Federal Aviation Administration
Aviation Rulemaking Advisory Committee

General Aviation Certification and Operations Issue Area
JAR/FAR 23 Harmonization Working Group

Task 6 – Disposition of Comments to NPRM 94-19, 94-20 and 94-22

Airworthiness Standards; Powerplant Rules Based on European Joint Aviation Requirements

FIGURE A7 - CHORDWISE LOAD DISTRIBUTION FOR STABILIZER AND
ELEVATOR OR FIN AND RUDDER

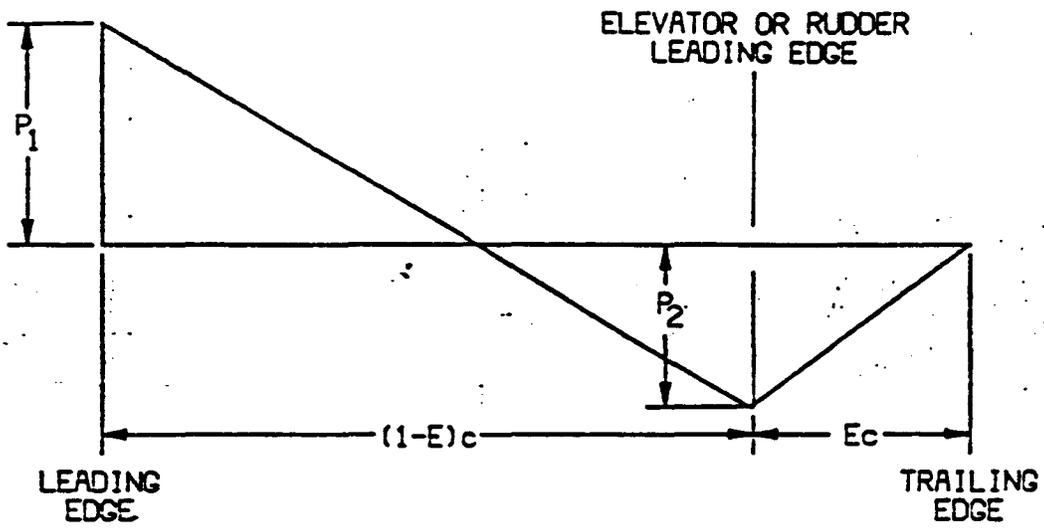
The FAA proposed to revise three areas of Appendix A: (1) A23.1 General; (2) A23.11 Control surface loads, paragraph (c), Surface loading conditions; and (3) Table 2 - Average limit

control surface loading. The FAA proposed to add a new figure to Appendix A: Figure A7, Chordwise load distribution for stabilizer and elevator, or fin and rudder. The revisions specify the configurations for which the wing and tail surface loads, required by A23.7, are valid. The FAA discovered a need for a clarification change in paragraph A23.a(a)(1) during the post comment review period. The words "excluding turbine powerplants" are clearer than the words "excluding turbines." This revision is included in the final rule to more clearly convey the intended meaning.

(ii) The load on the stabilizer and elevator, and the load on fin and rudder, must be distributed chordwise as shown in figure 7 of this appendix.

Figure A7.—Chordwise Load Distribution for Stabilizer and Elevator or Fin and Rudder

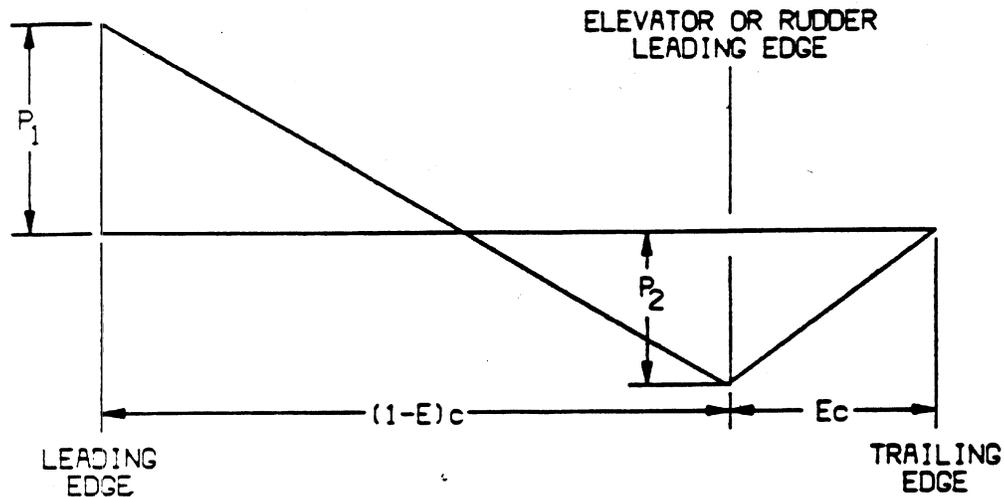
The FAA proposed to revise three areas of Appendix A: (1) A23.1 General; (2) A23.11 Control surface loads, paragraph (c), Surface loading conditions; and (3) Table 2—Average limit control surface loading. The FAA proposed to add a new figure to Appendix A: Figure A7, Chordwise load distribution for stabilizer and elevator, or fin and rudder. The revisions specify the configurations for which the wing and tail surface loads, required by A23.7, are valid. The FAA discovered a need for a clarification change in paragraph A23.a(a)(1) during the post comment review period. The words "excluding turbine powerplants" are clearer than the words "excluding turbines." This revision is included in the final rule to more clearly convey the intended meaning.

distributed chordwise as shown in figure 7 of this appendix.
